6103 West Boulevard (COMPLETE APPLICATION)
DP-2019-00404 - C-2

DEVELOPMENT PERMIT STAFF COMMITTEE MEMBERS

DEVELOPMENT PERMIT STAFF COMMITTEE RECOMMENDATION: APPROVE

Figure 4: North-South Building Section Looking West

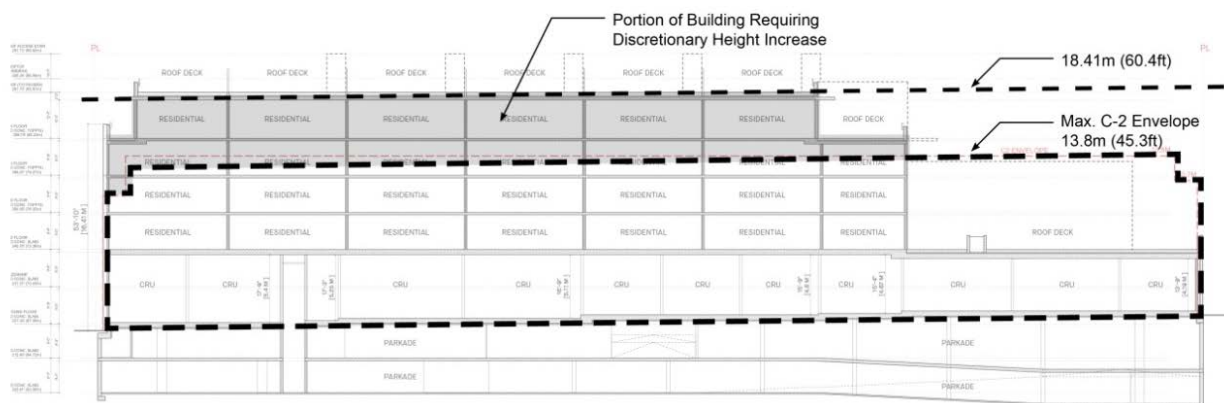
The application proposes a five-storey building projecting into the permitted 13.8 m (45.3 ft.) height envelope as shown in Figure 4. The proposed height is 19.8 m (64.96 ft.), as measured to the guardrails at the rooftop deck. The height to the top of the roof itself is approximately 18.41 m (60.4 ft.). The fifth storey is associated with the requested 10% heritage bonus density, as well as the height of the ground floor commercial units. The bonus density is proposed to be located in a fifth storey at the new building in

order to limit impact to the original one-storey heritage building. The addition above the heritage building is limited to two-storeys with significant setbacks from the roof edges to minimize its presence.

The height of the ground level of the new building is raised to match the reconstructed roof level of the heritage building at 5.1 m (16.75 ft.) measured to the top of the roof. By doing so, the ground level meets the generally recommended minimum of 15 ft. floor-to-floor height for commercial uses. It is noted that the site is sloping with a 1.14 m (3.74 ft.) drop southward along West Boulevard and a south-west cross fall of 1.67m (5.5 ft). This increases the height of the ground level to 5.93 m (19.45 ft.) at the southeast end of the development. The alignment of the ground floor with the S.E.P. Block provides for a respectful integration with the heritage building. It also allows for a generous commercial floor height to facilitate a variety of retail and service uses and ensure continued commercial viability.

Figure 5: East-West Building Section Looking North

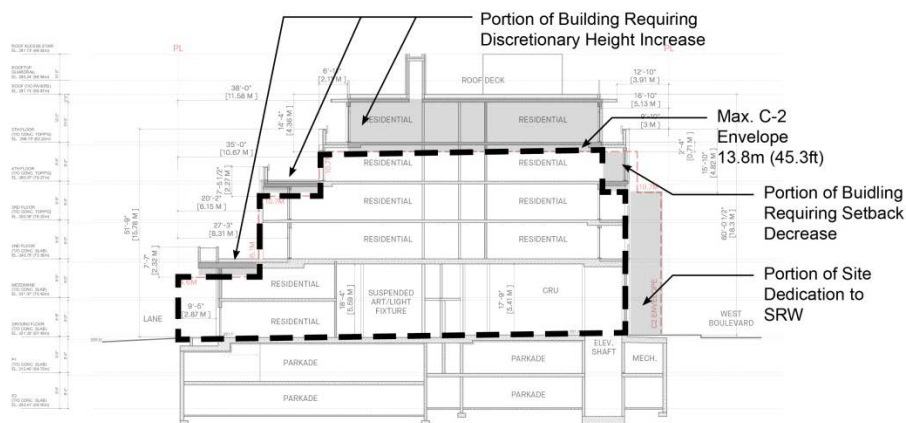
The high ground floor also allows for a mezzanine level at the rear and the provision of two-storey (with mezzanine) ground-oriented townhouse units facing the lane which will enhance the residential character of the lane. A stepped building profile is provided at the rear in keeping with the intent to provide a transition to single-family zoning across the lane. The rear setbacks meet with the expectations of the C-2 zoning (See Figure 5).

At the street-facing elevations, staff support the provision of a shoulder setback at the 5th floor instead of the 4th floor, as it reduces the overall scale of the building and creates a street wall that is proportional to the overall building height.
